Turbo HD DVR V4.84.002build250922 Release Notes

Reason of Upgrade

Modify the product design, add new functions and optimize the user experience.

3. The number of support perimeter function have improved on Pro series

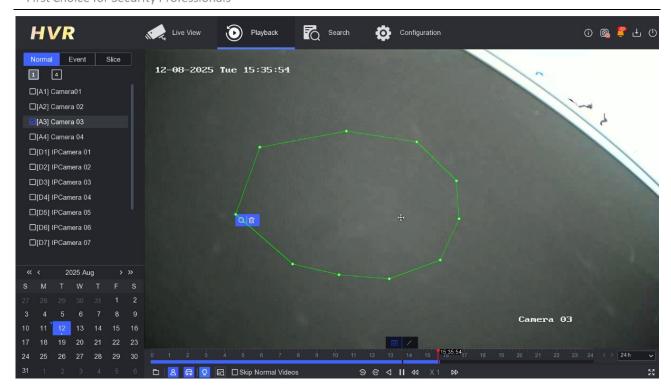
- a. From the original 8-ch to the current 16-ch
- b. Device Model Range: 7232HQH/16HUH-M/XT、7216HUH-M/PXT

6. Supports Khmer language for the Cambodia region

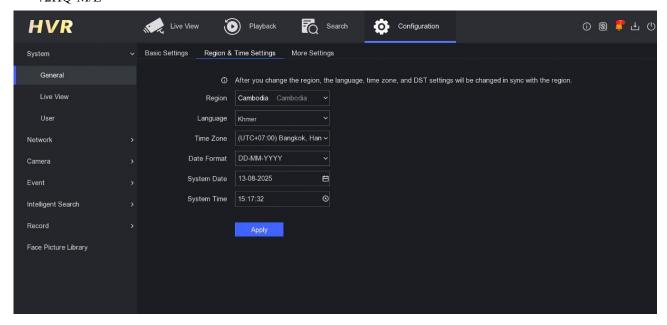
- a. The local interface for Asian language packages supports Khmer in the Cambodia region
- b. Device Model Range: 72HQ/HU/HT-M/XT、72HU-M/PXT、71/72HQ-M/T、72HU-M/T、71HQ-M/S、72HO-M/E

7. Email service address preset general mailbox

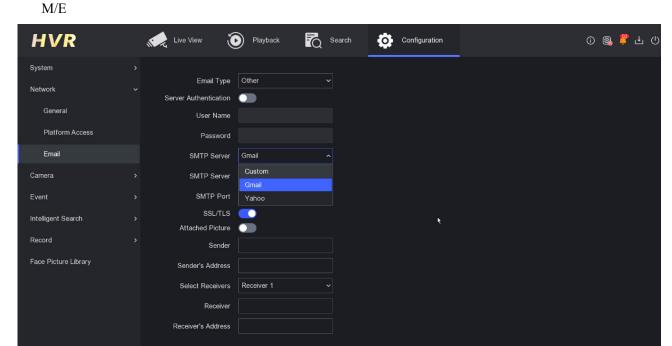
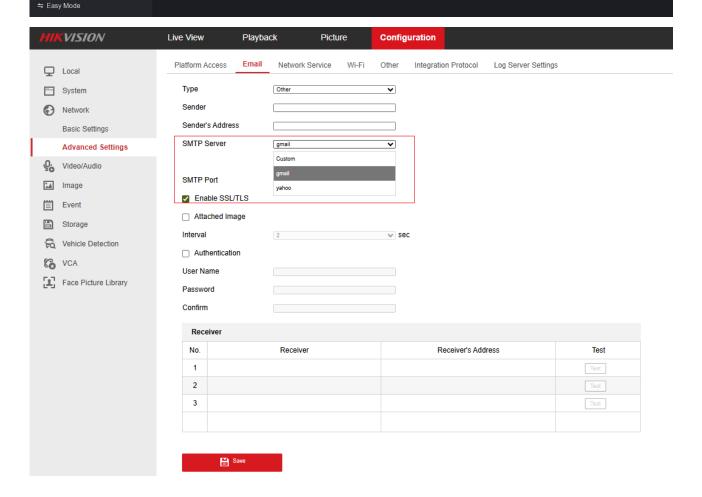
- a. The SMTP Server dropdown at the Email location presets Gmail and Yahoo email
- b. Select the preset email account to automatically associate SSL/TLS and port number configurations, email preset configuration:

Gmail port number: 587 Enable SSL/TLS Yahoo port number: 587 Enable SSL/TLS

c. Device Model Range: 72HQ/HU/HT-M/XT、72HU-M/PXT、71/72HQ-M/T、72HU-M/T、71HQ-M/S、72HQ-

8. Add display of device short serial number in system information

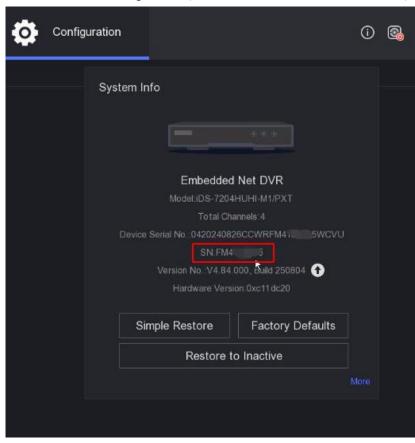
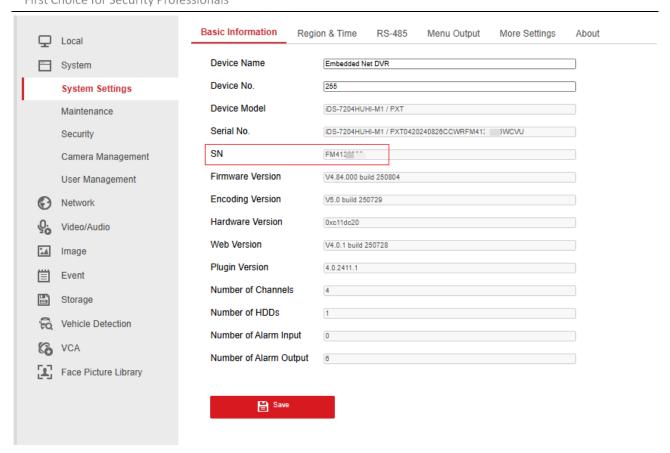
- a. Add short serial number display in system information for WEB and local
- b. Device Model Range: 72HQ/HU/HT-M/XT、72HU-M/PXT、71/72HQ-M/T、72HU-M/T、71HQ-M/S、72HQ-M/E

9. New negative pressure configuration item added for POC model

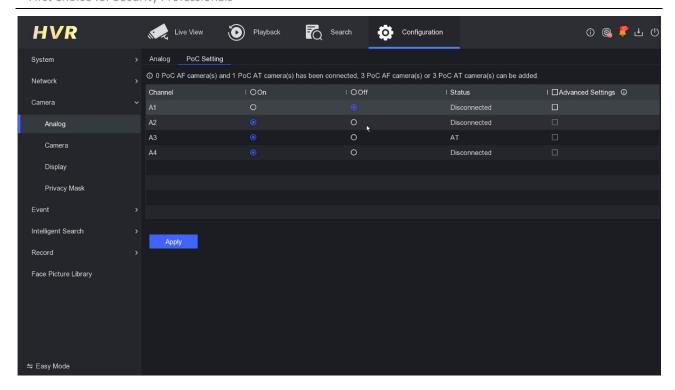
To resolve the issue of image distortion when POC models are used with AC-coupled cameras, a new negative pressure disable configuration has been added to the POC disable configuration interface. This configuration can only be enabled when PoC is disabled.

- a. After the negative pressure configuration is disabled, some front-end cameras (including PTZ dome cameras) may experience PTZ malfunction, which is a negative effect of enabling this configuration;
- b. After the negative pressure configuration is disabled, the AC coupled camera plug-in and plug-out signal will take effect in about 15 seconds to ensure normal image display;
- c. Device Model Range: 72HU-M/PXT

10. Outlook email supports the OAuth2.0 authentication method

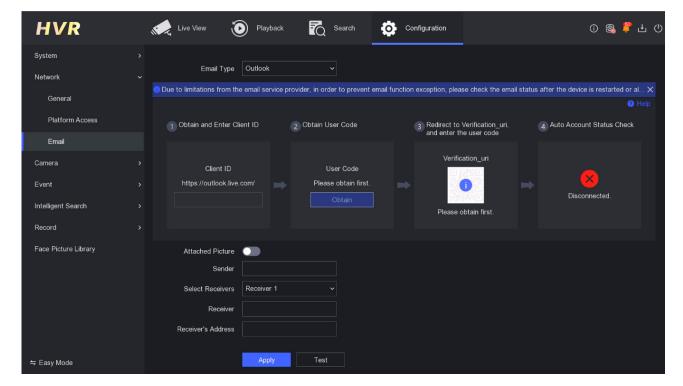
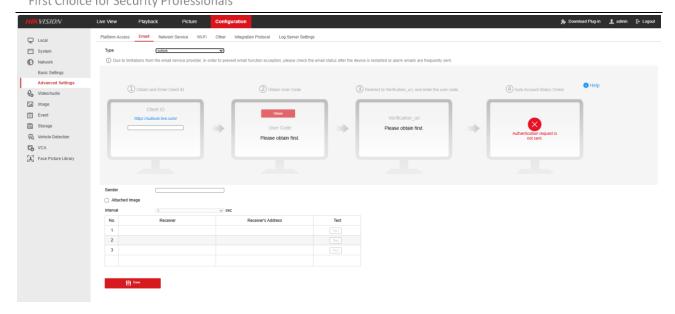
- a. Outlook email's original account password method is no longer supported and has been upgraded to use the new OAuth2.0 authentication method for authentication
- b. Device Model Range: 72HQ/HU/HT-M/XT、72HU-M/PXT、71/72HQ-M/T、72HU-M/T、71HQ-M/S、72HQ-M/E

11. Search Interface Function Optimization

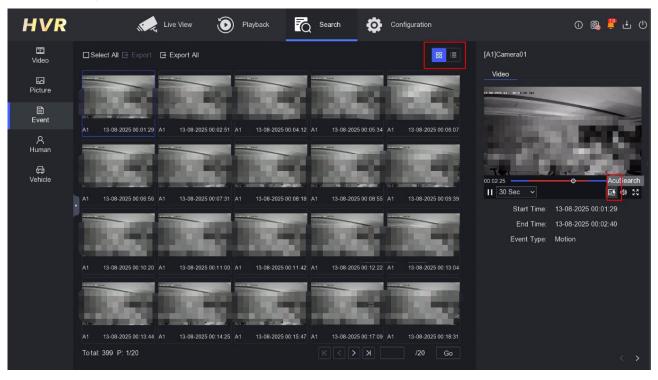
- a. Add AcuSearch function entry in the small window playback of event search result for user convenience
- b. Double-click to zoom in and double-click to zoom out function are added to the playback small window
- c. Right-click mouse to add return function
- d. Video, image, and event search results add chart mode

12. Acusearch Function Optimization

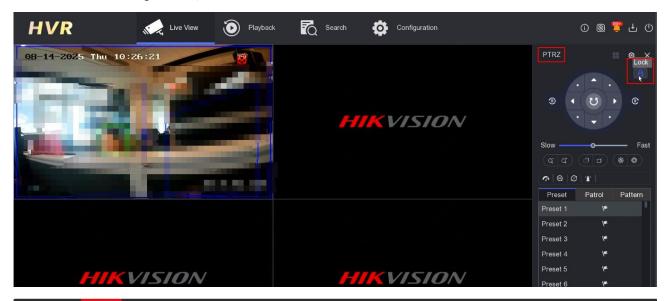
- a. Acusearch function search result adjustment: personnel default similarity 70%, vehicle default similarity 75%
- b. During the search process, progress is displayed. Results that meet the similarity requirements are prioritized. After the search is completed, the results are sorted and displayed, with a maximum of 500 search results

displayed.

- c. Optimize modeling search strategy (proportional sampling priority modeling), so that when the modeling data volume is large, each channel has a certain number of target modeling detections
- d. Device Model Range: 72HQ/HU/HT-M/XT、72HU-M/PXT

15. Modification of Associated Configuration for the Chile Region

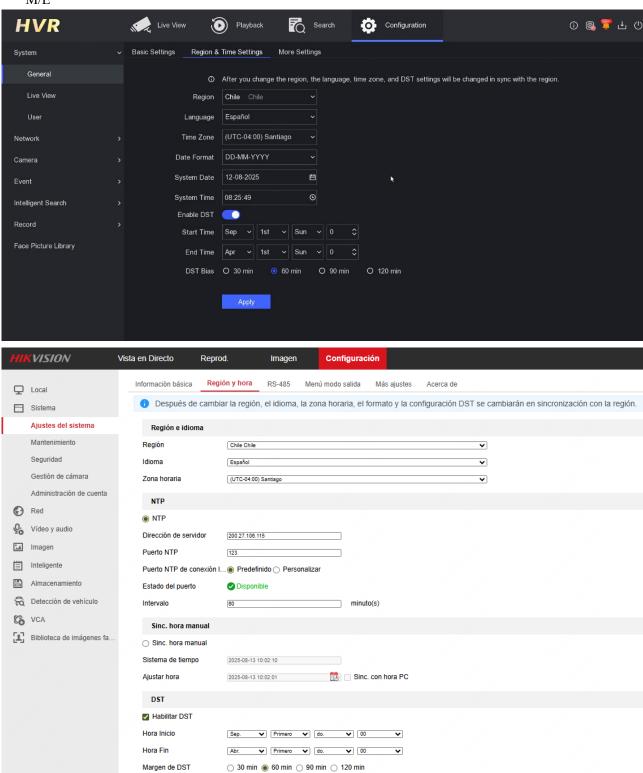
After selecting the Chile region, the following default configuration is associated:

a. Time zone selection -4 (always select -4, time zone changes are switched by DST)

- b. The device is enabled with NTP, IP is 200.27.106.115
- c. The device enables DST, start time: first Sun of September 00, end time: first Sun of April 00
- d. Device Model Range: 72HQ/HU/HT-M/XT、72HU-M/PXT、71/72HQ-M/T、72HU-M/T、71HQ-M/S、72HQ-M/E

16. Add a prompt description in the advanced configuration of the recording schedule

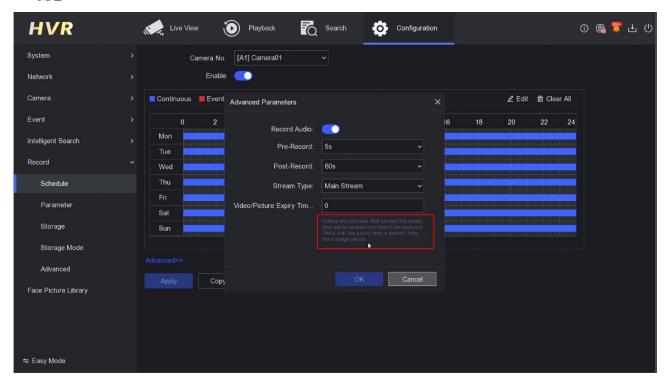
- a. Added a note in the advanced configuration of the recording schedule: Videos and pictures that exceed the expiry time will be erased and cannot be restored. Note that the expiry time is distinct from the storage period.
- b. Device model range: 72HQ/HU/HT-M/XT、72HU-M/PXT、71/72HQ-M/T、72HU-M/T、71HQ-M/S、72HQ-M/E
